September 30, 2014

Third Modification to EPA's Final Determination for the South Terminal Project – Additional Dredging to Widen Channel and Associated Blasting for Rock Removal

THIRD MODIFICATION SUMMARY: After completing consultation with other federal and state agencies, as required by federal and state law, and after reviewing additional submissions by the Commonwealth of Massachusetts ("the Commonwealth"), EPA has determined that the Commonwealth's request for a Third Modification to EPA's Final Determination for the South Terminal Project, issued on November 19, 2012, as modified by the First Modification dated February 4, 2013, and the Second Modification dated September 30, 2013, (altogether referred to as "the Final Determination, as modified" or "FD, as modified") is both protective of human health and the environment, meets the substantive requirements of applicable or relevant and appropriate federal environmental standards and, through the Commonwealth's determination, meets applicable or relevant and appropriate state environmental standards, as long as the conditions set forth in this Third Modification are met. Through this Third Modification, EPA is modifying the

Figure 1

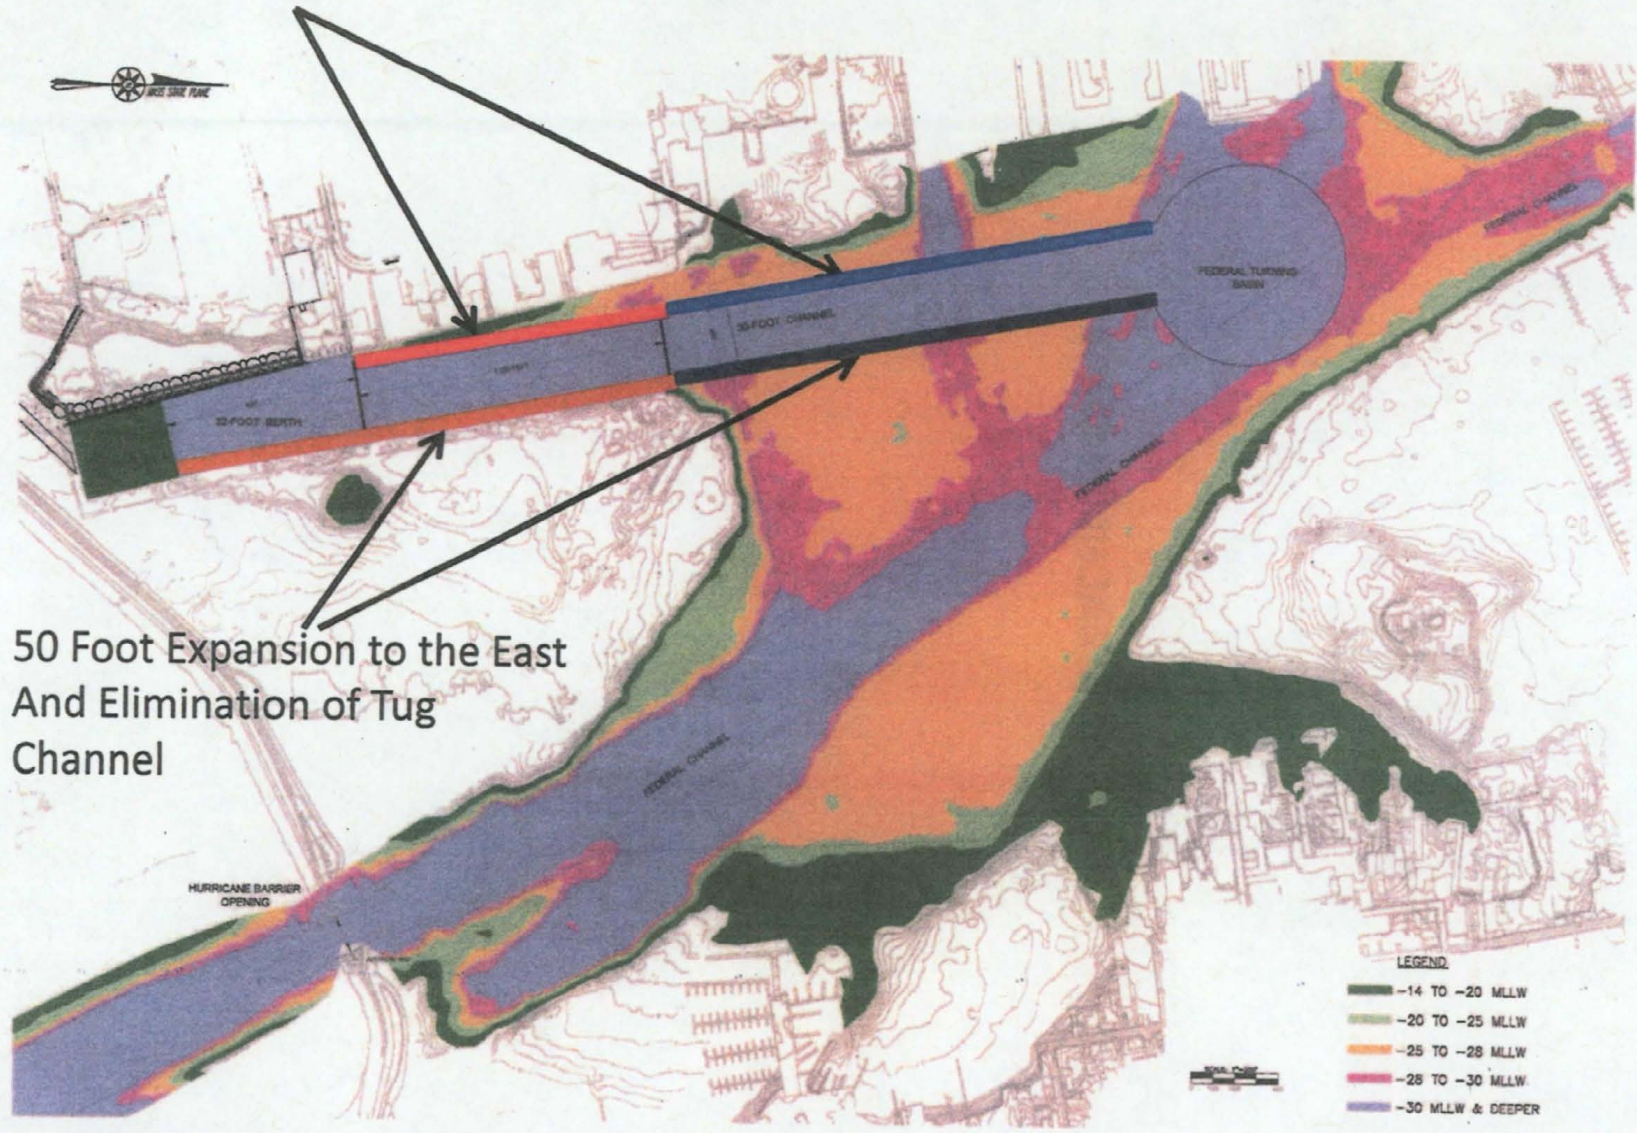
The dredging volume table originally attached as Table 1 to the Final Determination has been revised and is attached as Table 1 to this document. A map depicting the reconfiguration of the navigational channel and tug channel to a 300 foot wide channel is attached as Figure 1 to this document. A map of the subtidal blasting areas is attached as Figure 2. A map of the additional winter flounder mitigation area is attached as Figure 3.

The additional 25 foot width channel expansion will occur on the western, or landward, side of the 225 foot channel authorized in the Second Modification in areas that have historically been dredged, either by the U.S. Army Corps of Engineers (west of the

EPA has reviewed the archeological investigations in relation to the proposed additional dredging and the previously identified paleosols area. (See Figure 4 for map of areas of archeological survey.) The paleosols are located between the former Gifford Street boat ramp and the southern edge of the newly constructed terminal facility. (See Figure 5 for a mapped location of the paleosols area.) The expanded dredge area, although expanding laterally both east and west of the already authorized navigational channel, does not extend any further south than previously authorized dredging areas. The southern end of the 25 foot western lateral expansion stops north of the existing Shuster property; the southern end of the eastern lateral expansion stops approximately halfway along the edge of the newly constructed terminal. Neither expansion area is closer to the paleosol area than previously authorized dredging. See Figure 1.

Figure 2

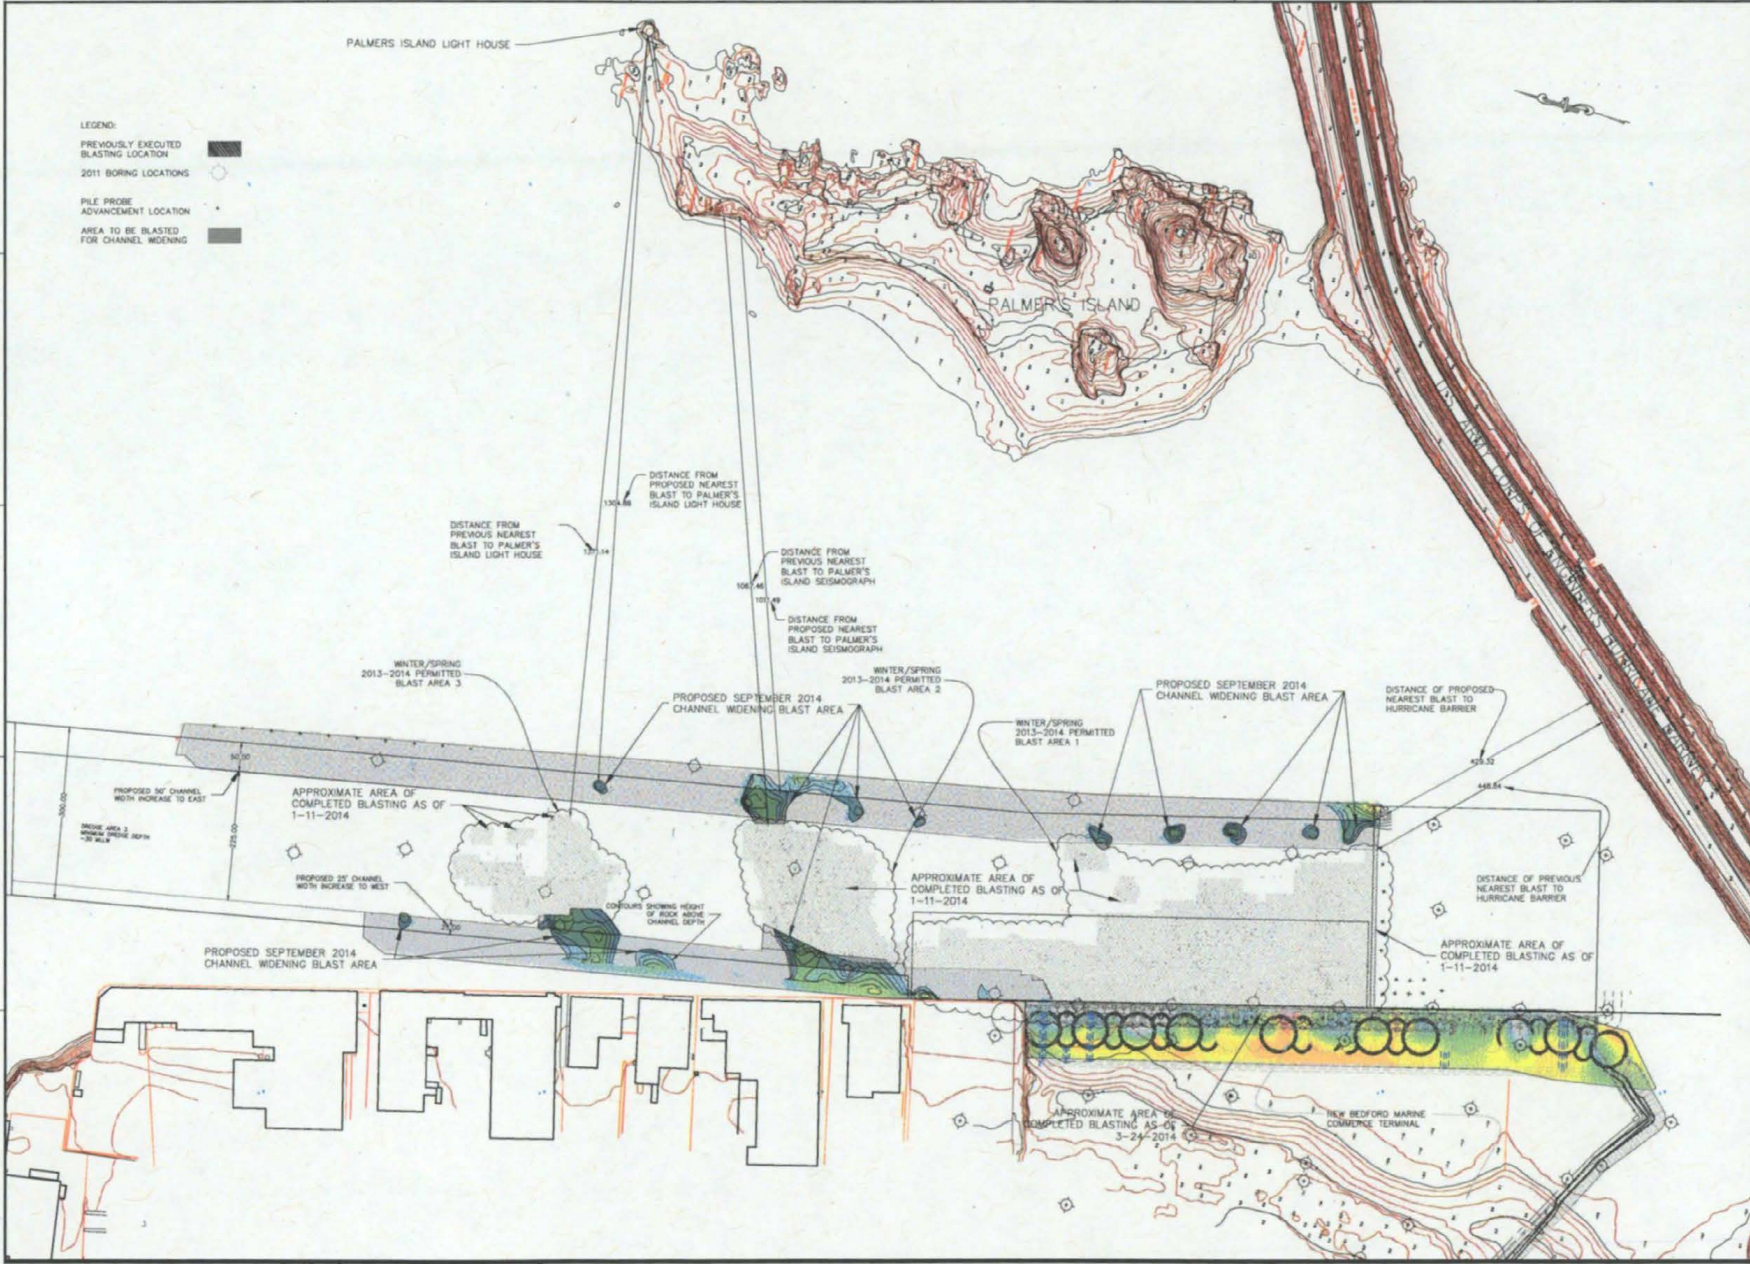
The July 25, 2014 submission also included a request for additional blasting as a rock removal method associated with the requested expansion. The Commonwealth requested that the blasting be authorized to occur prior to September 1, 2014 for several reasons including the continued presence of blasting equipment in the area, the fact that clean overburden material has not yet been dredged within the proposed blasting areas, and the project construction schedule. In the Second Modification, EPA authorized the use of blasting as a rock removal method in three areas during construction of the terminal bulkhead and channel dredging. That approval was based on, among other things, mitigation measures that would be taken, the results from a JASCO Applied Sciences acoustic model which described peak pressure and impulse impact thresholds for explosive charges up to 150 pounds, and input from state and federal agencies, including the U.S. Army Corps of Engineers regarding impacts to the Hurricane Barrier, from NMFS regarding impacts to the Atlantic sturgeon, an endangered species, as well as other aquatic life, and from the Massachusetts Historical Commission regarding impacts to the Palmer Island Light Station. See EPA's Second Modification.

Figure 3

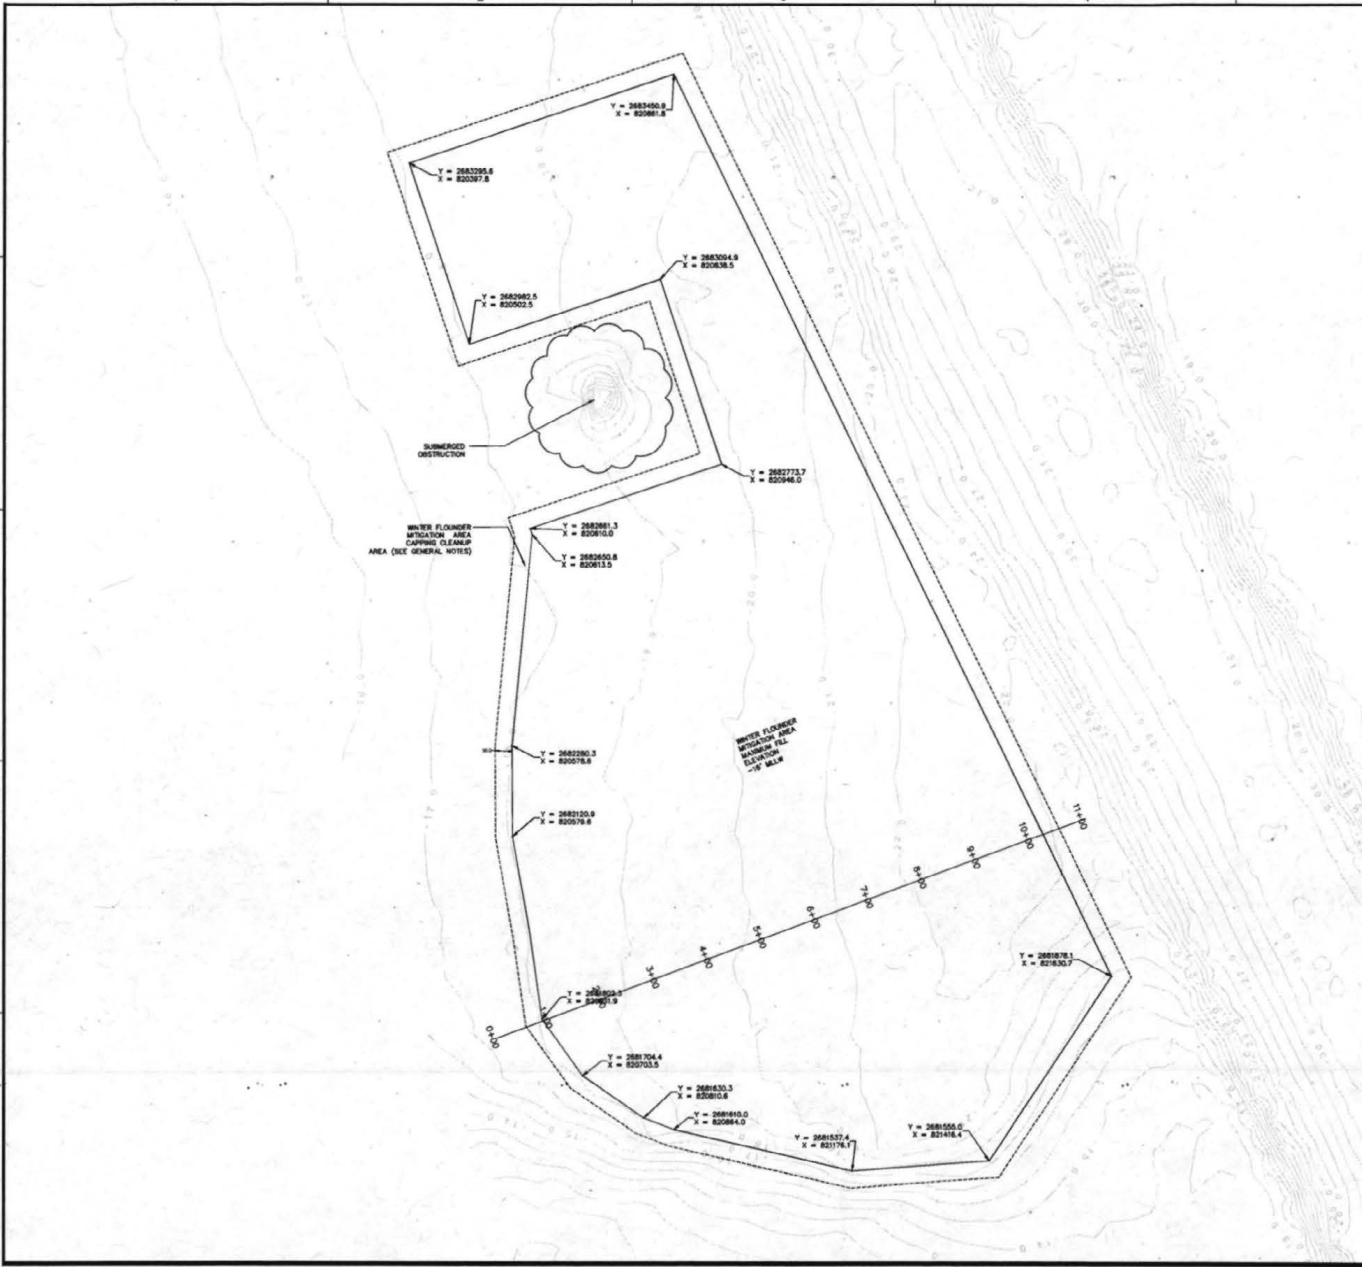
- Creates 4.6 additional acres of winter flounder habitat at the winter flounder mitigation area;
- Clarifies upland remediation at the Radio Tower parcel to include offsite disposal of material containing PCB-concentrations greater than or equal to (" \geq ") 50 ppm, capping and a change from ancillary to heavy load use; and
